# **Report on Indiana Michigan Power Company 2018-19 Integrated Resource Plan**

**Submitted to the IURC on December 2, 2019**

**On behalf of CAC, Carmel Green Initiative, Earthjustice,  
IndianaDG, Sierra Club, and Valley Watch**

**Figure 1. Bids Received in Response to NIPSCO’s 2018 All-Source RFP<sup>9</sup>**

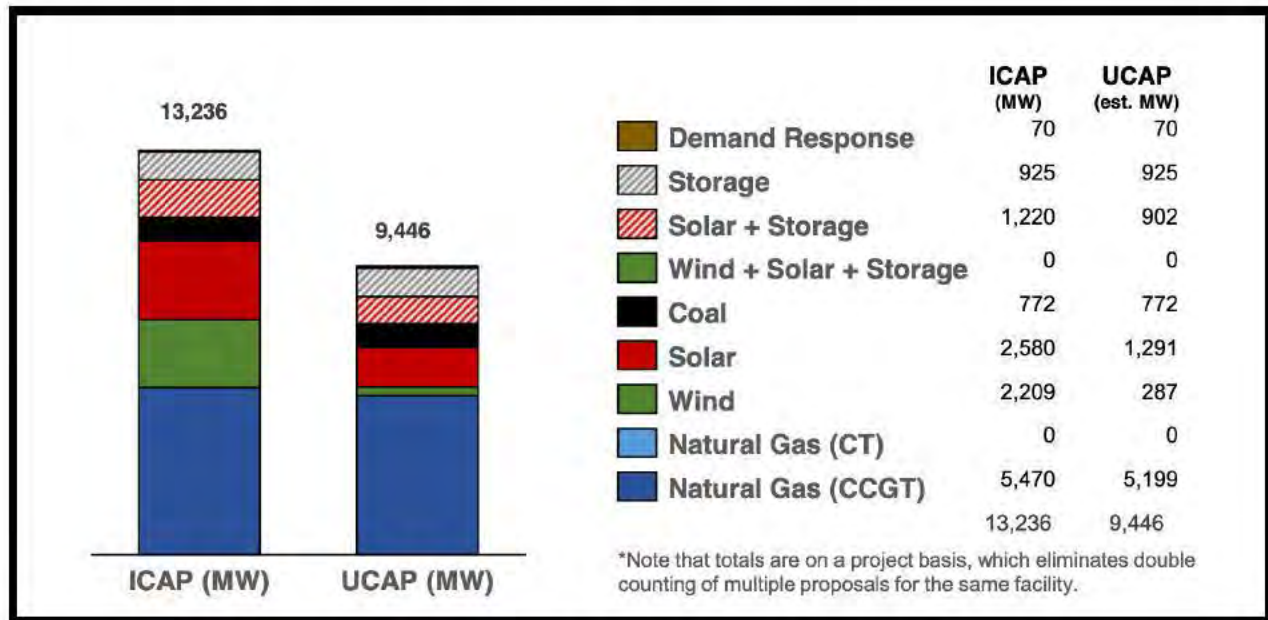
solar + storage hybrid projects (Figure 1) in its 2018 IRP—far more than I&M is even allowing Plexos to select over the entirety of the planning period.

Indeed, in addition to the cumulative limit of 1,700 MW of solar, I&M placed an annual limit on solar so that Plexos could not even select a full 300 MW of solar in each year of the planning period. Solar is first available in Plexos in 2022 and the last year of I&M’s planning period in 2049, that is a 29-year period over which only 1,700 MW<sup>10</sup> of solar can be picked, i.e., an average of 59 MW per year. The limits are arbitrary and not reasonably supported by I&M.

Similarly, I&M’s wind limits are unsubstantiated. The annual limit of 300 MW is well below what can be implemented without constraining ownership to I&M. For example, just one of NIPSCO’s wind farms is 400 MW alone. And I&M’s 2,100 MW<sup>11</sup> limit over the planning period is less than the 2,209 MW of wind NIPSCO received in response to its 2018 all-source RFP. Given the 29-year planning period, the 2,100 MW planning period limit amounts to an average of only 74 MW of wind per year. Nor is I&M’s reliance on Department of Energy’s Wind Vision Report appropriate for setting this limit. The intent of the report was to explore a scenario of 10% wind energy throughout the entire nation in 2020, 20% in 2030, and 35% in 2050. It is not a cap on the amount of wind nor would it be reasonable to think that the level of

**Figure 2. Incremental Annual Cumulative Net Present Value Revenue Requirement to Base Optimization<sup>28</sup>**

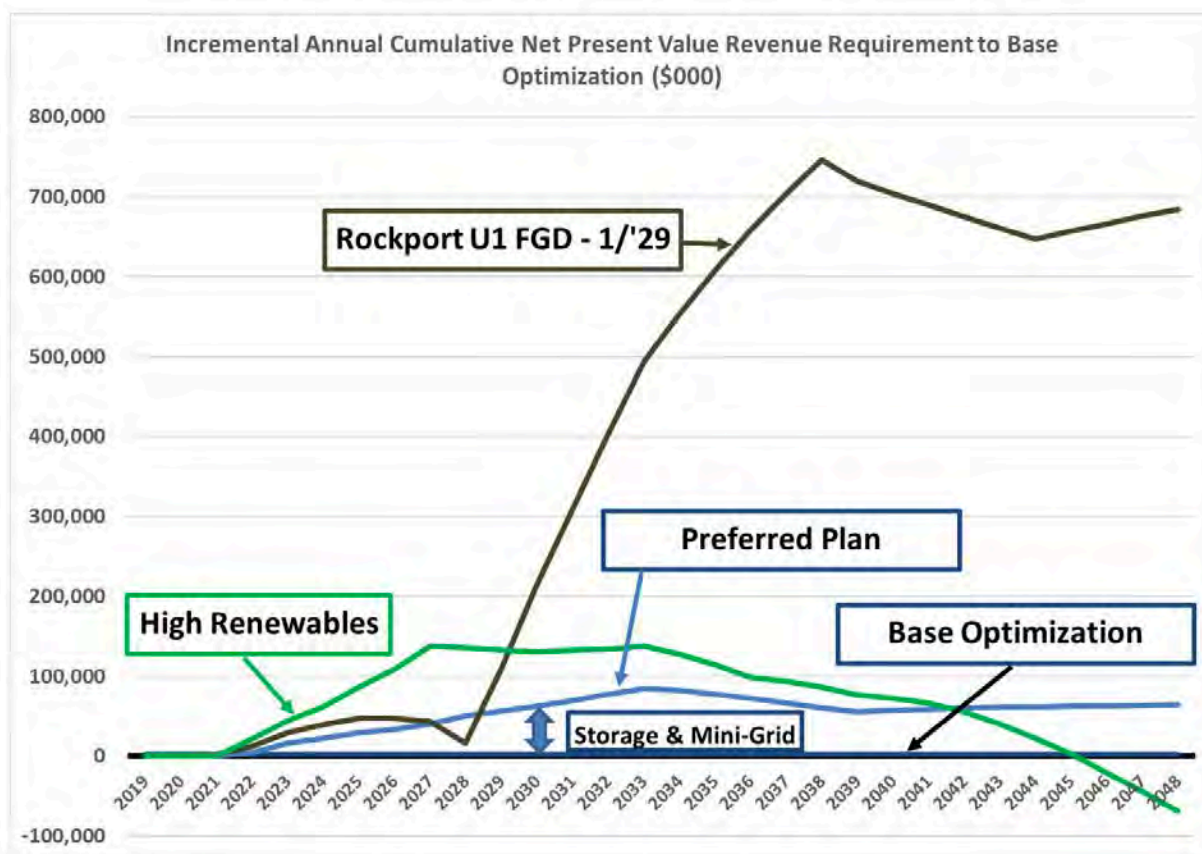
I&M argues that the so called High Renewables plan would have a larger rate impact in the near term in comparison to the other plans shown in Figure 2.

But this differential in revenue requirements is likely to be distorted by I&M’s incorrect modeling of wind and solar prices and the unreasonably low cost it assumed for gas combined cycle units (“CCs”) as discussed in Section 3.2, below.

Figure 4. I&M Historical and Forecasted Sales by Customer Class<sup>40</sup>

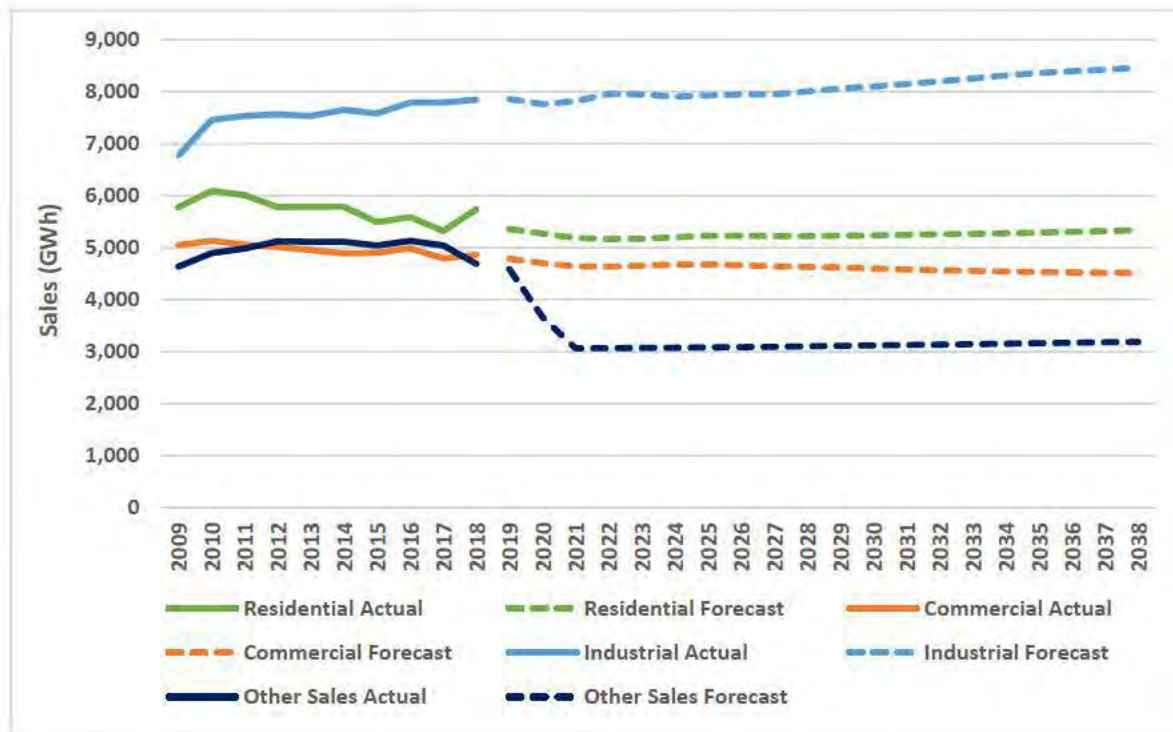
Due to slower growth of sales in some of the customer classes and the loss of certain wholesale customers, I&M’s forecasted sales have a lower average growth rate than the historical. Figure 4 shows the comparison between historical and forecasted sales across each of I&M’s customer classes. I&M is forecasting a drop in wholesale customers which results in a large dip in sales.

I&M also projects that Company wholesale customer sales will decrease from 4,509 GWh in 2019 to 3,586 GWh in 2020 and then 2,988 GWh in 2021.<sup>39</sup>

**Figure 7. I&M Residential “Realistic Achievable” Cumulative Savings from AEG MPS (GWh)**

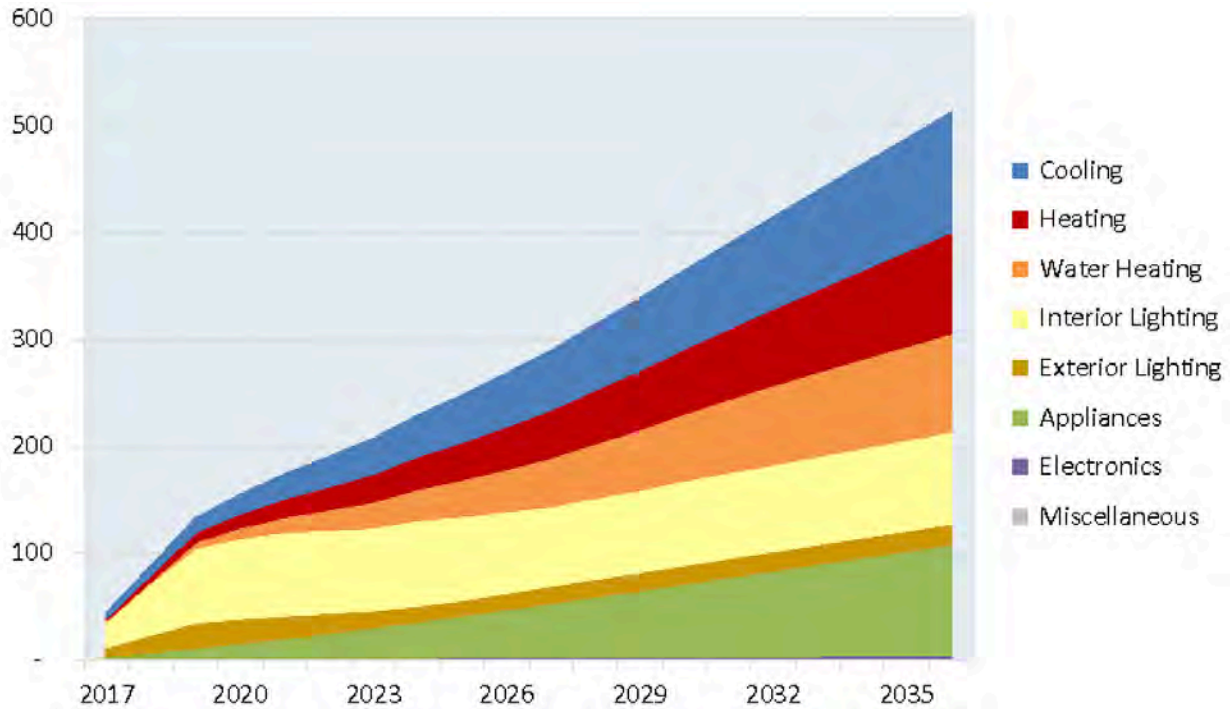
While residential lighting is a measure with significant savings in contemporary MPSs performed on behalf of Vectren<sup>50</sup> and Indianapolis Power and Light,<sup>51</sup> it was not included as a bundle for potential selection until 2030 in I&M’s modeling. I&M’s MPS does show significant cumulative savings from residential lighting, as shown in Figure 7, below, but the MPS only reports cumulative savings by end-use from 2017 onwards, not incremental savings. So it is impossible to accurately separate the incremental potential for lighting savings from the savings from prior measure installations that may or may not be rolling off.

Nevertheless, this figure from I&M’s AEG MPS certainly does not support an assumption of zero incremental residential lighting savings through 2030. Indeed, I&M does not even believe that is a reasonable assumption in the near term since I&M Witness Jon Walter testified in his direct testimony filed in Cause No. 45285 that I&M’s upcoming three-year DSM plan includes a program with a residential lighting component.<sup>52</sup>

**Figure 8. I&M Historic Savings Goals Are Materially Higher than Net Potential in MPS**

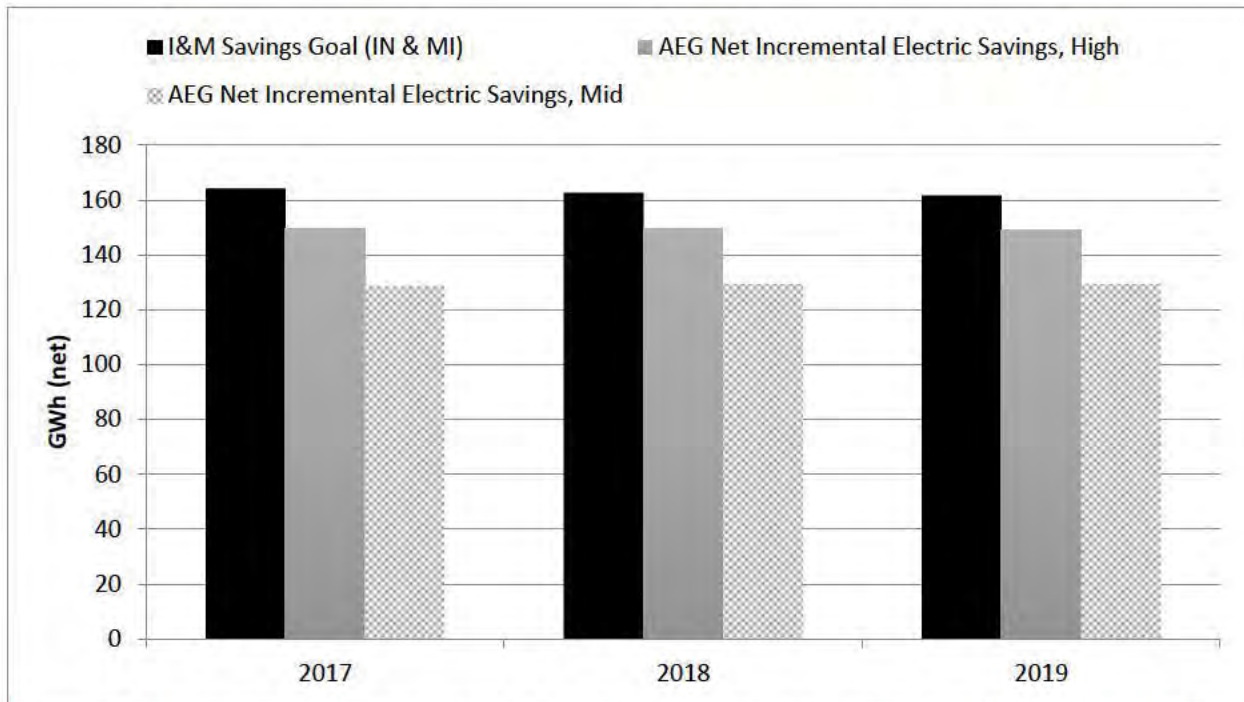
Initially, I&M planned to base its EE bundles only on the Top 20 measures in terms of cumulative annual savings in the MPS. After input from stakeholders, “potential was added from measures outside of the top 20 measures into a ‘miscellaneous’ bundle for each sector.”<sup>53</sup> Yet, incremental savings either in the MPS – which are theoretically supposed to be based on maximum achievable cost-effective savings - do not even reach the modest levels in I&M’s historic combined goals across Indiana and Michigan service territories as shown in Figure 8 below.

The black bars show I&M’s combined savings goals across its two-state territory and are significantly higher than I&M’s AEG MPS savings.

**Figure 9. IRP Cannot Result in Level of Savings Equal to I&M's Current Goals**

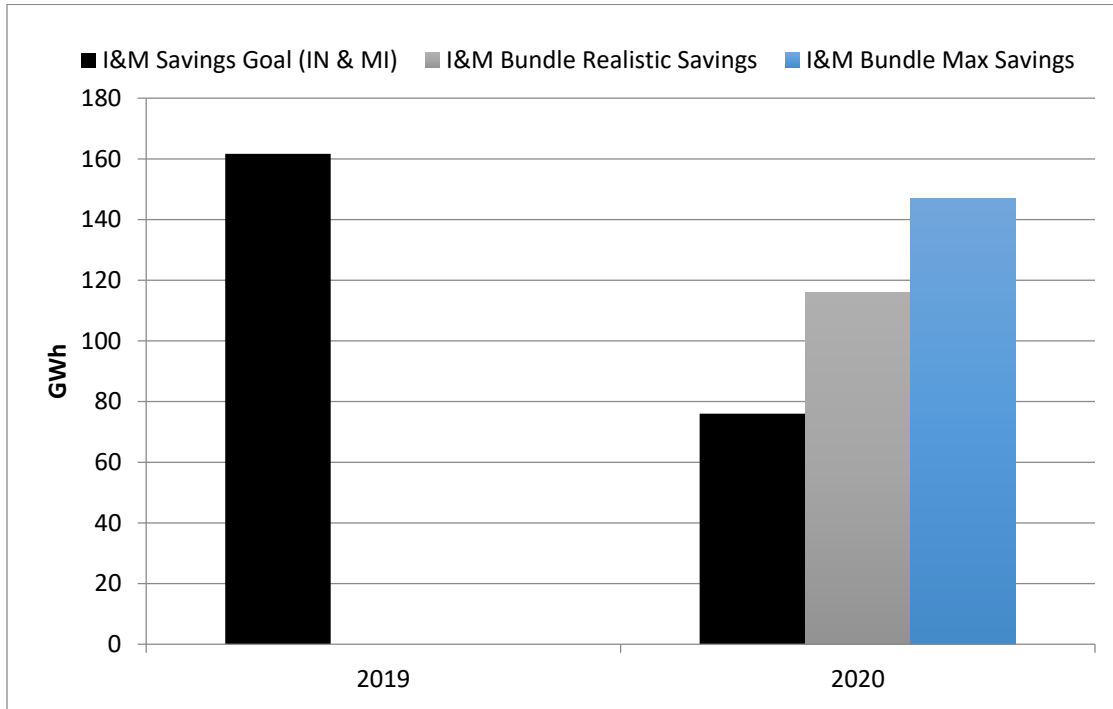
The IRP bundle savings also do not match up with I&M’s most recent goals as show in Figure 9. Note that the 2020 goals are based on this IRP and are a function of the very low potential modeled in I&M’s bundles as well as the elevated cost of those bundles.

**Figure 10. 2019 EE Budget Achieved More Savings at Lower Cost than IRP Bundles Would**

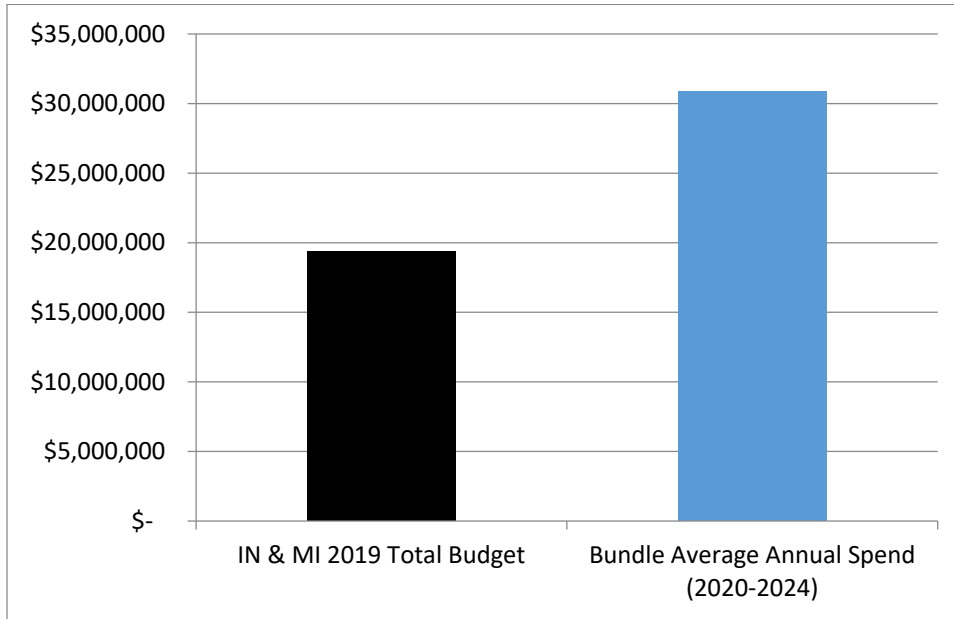
The cost of the IRP bundles may be different than the MPS costs - we are not clear on that point because savings are grouped in the bundles differently than they are in the MPS. But whatever the source of the bundle costs, they are dramatically higher than I&M's two-state EE budget for 2019 (Figure 10 below) which is forecasted to achieve much higher savings as shown in Figure 9 above. In other words, I&M's customers are getting more savings for less money in 2019 than what I&M has modeled for 2020 and beyond.

I&M has utterly failed to model EE savings in any way that represents a) the manner in which those savings are actually achieved, b) a level consistent with its own MPS, or that represents c) the likely maximum achievable level of savings. These errors compounded upon other errors explained above create fatal, irredeemable flaws in I&M's 2018-2019 IRP.

Figure 12. I&M's 2020 Energy Mix

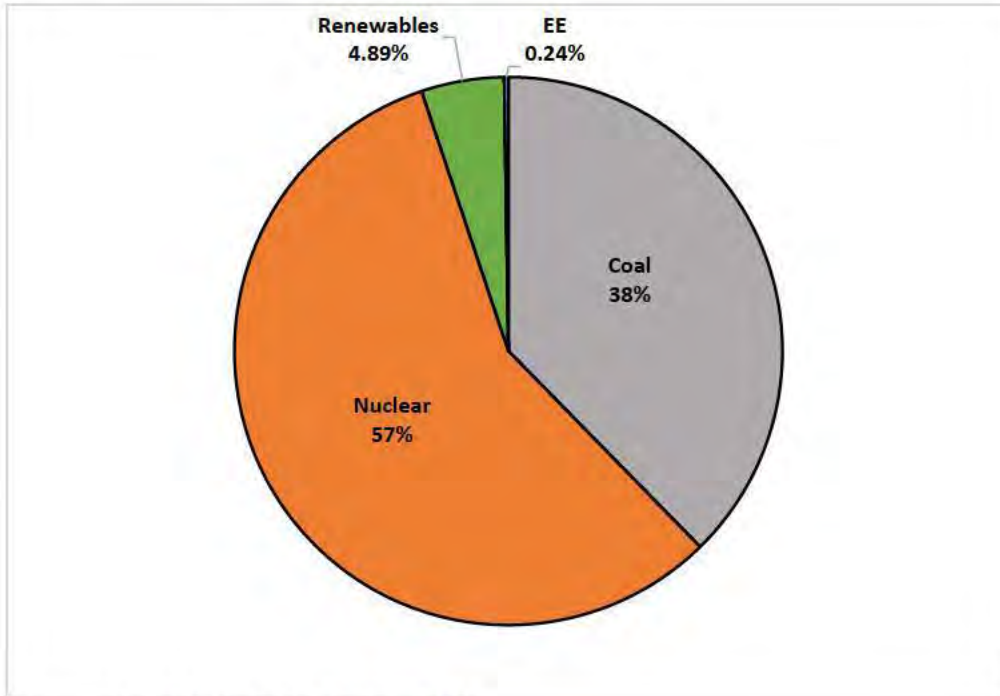
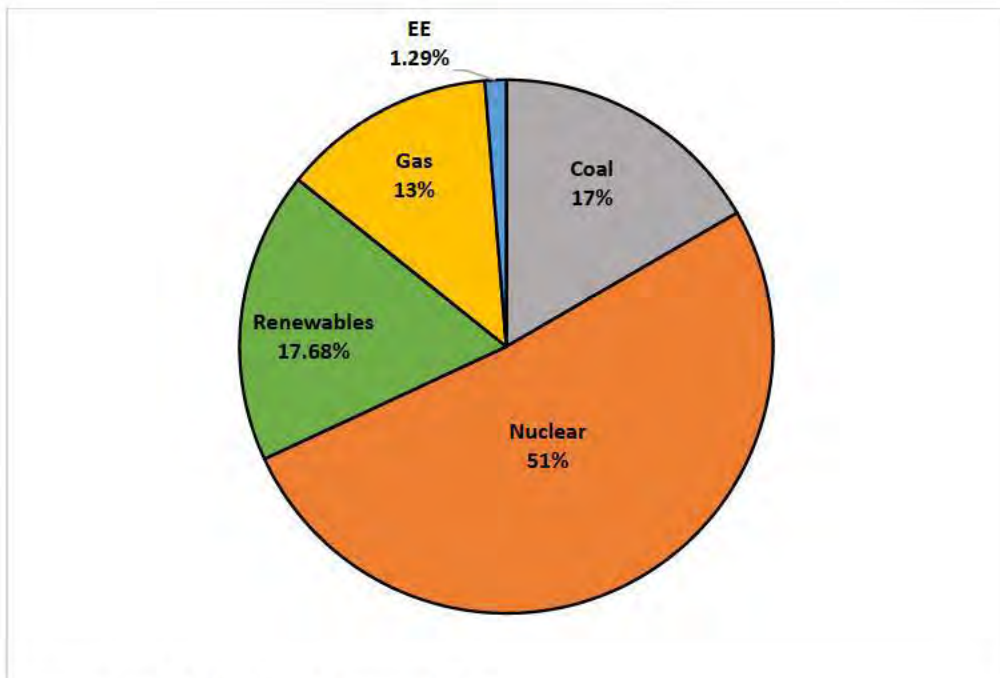
I&M’s short-term action plan is a product of the many flaws contained in its IRP. I&M’s biases against energy efficiency, wind, and solar in favor of thermal resources, result in a plan that underutilizes the first category and over utilizes the second. The result is a plan that goes from being very heavily dependent on thermal resources, specifically coal and nuclear power, to one that is still dominated by thermal resources that now includes gas, as shown in Figure 12 and Figure 13.
